**SUBJECT: Proposed Revisions to the Acceptance Criteria for Seismic Certification by Shake-Table Testing of Nonstructural Components, Subject AC156-0225-R2 (YM/MC)**

Subject: Updated Comments on Proposed ICC-ES AC156 September 2024 Draft

Date: October 22, 2024

**FIGURE 1—REQUIRED RESPONSE SPECTRUM, NORMALIZED FOR THE COMPONENT**

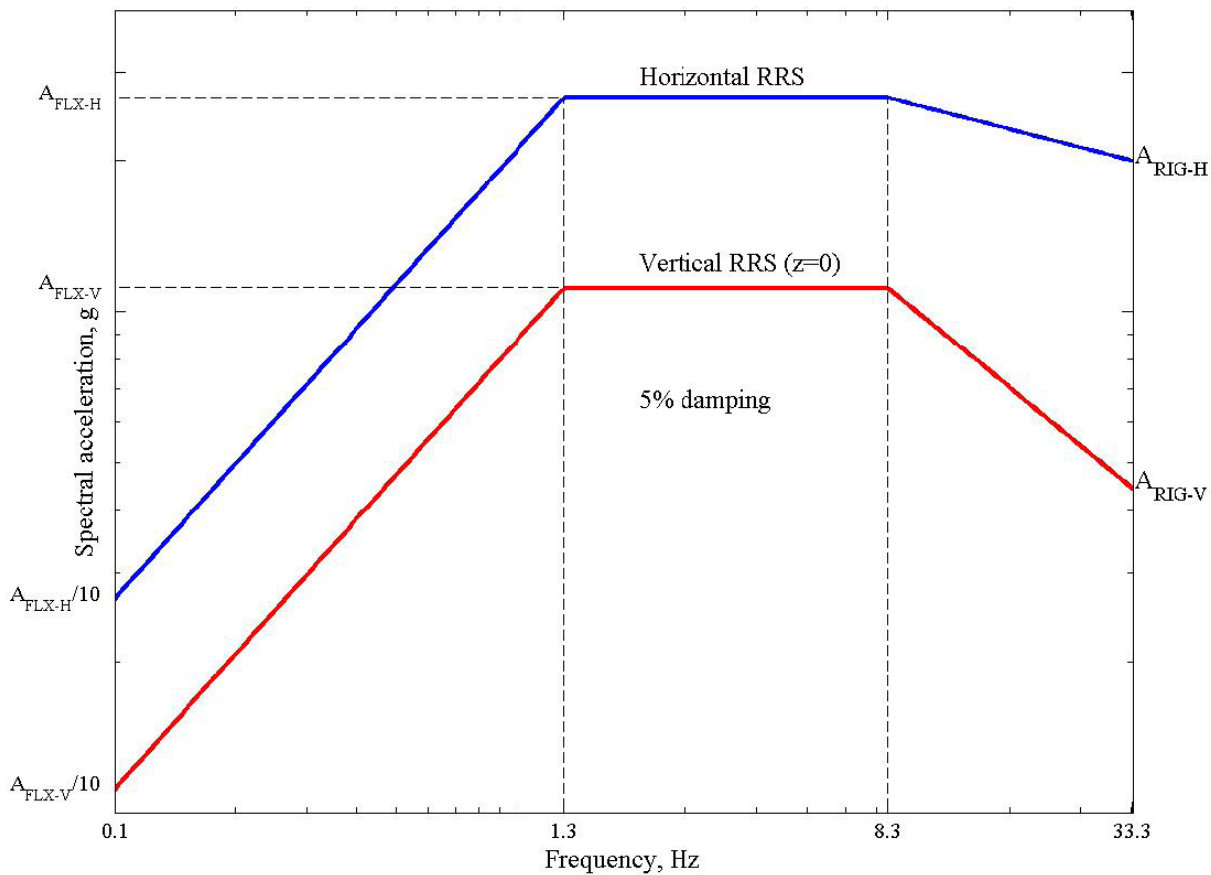
The AC156 Figure 1 shake-table test spectrum is equivalent to a generic building floor spectrum that is correlated to the ASCE/SEI 7 earthquake hazard design level ground motion demands. At grade plane elevation and below, the AC156 horizontal test spectrum must be equivalent in response acceleration to the ASCE/SEI design response spectrum as shown in ASCE/SEI 7-22 Figure 11.4-1 (shown below for reference). Thus, at grade plane elevation  $A_{FLX-H}$  must equal the peak response acceleration,  $S_{DS}$ , and  $A_{RIG-H}$  must equal the response acceleration at zero period (at  $T = 0$ ) which is defined as  $0.4 \times S_{DS}$ . It should be noted; the ratio between peak response and zero period response is 2.5 (1/0.4).

For nonstructural component installations located above grade plane elevation, the AC156 test spectrum must account for in-structure building amplification to account for the anticipated dynamic response of the building or nonbuilding structure. In-structure building amplification uses the building height ratio  $z/h$ , where  $z$  is the height in building structure at point of component attachment and  $h$  is the average roof height of building

Thus, the AC156 test spectrum is constructed by combining peak response and zero period response accelerations from the ASCE/SEI 7-22 design response spectrum from Chapter 11 with the in-structure building amplification factors contained in Chapter 13 lateral force equation. Since, the ASCE/SEI 7-22 made substantive changes to both Chapter 11 design response spectra with the addition of multi-period design spectra and in Chapter 13 with a new in-structure building amplification factor, in our opinion, the following changes to AC156 are required.

$$A_{FLX-H} = \frac{1.12 S_{DS}}{R_{\mu}} \left( 1 + 2.5 \frac{z}{h} \right) \quad \text{and} \quad A_{RIG-H} = \frac{0.4 S_{DS}}{R_{\mu}} \left( 1 + 2.5 \frac{z}{h} \right)$$

$$A_{FLX-H} = S_{DS} \left( \frac{H_f}{R_{\mu}} \right) \quad \text{and} \quad A_{RIG-H} = 0.4 S_{DS} \left( \frac{H_f}{R_{\mu}} \right)$$

where  $A_{FLX-H}$  is limited to a maximum value of 1.6 times  $S_{DS}$  or value of 3.2, whichever is higher.
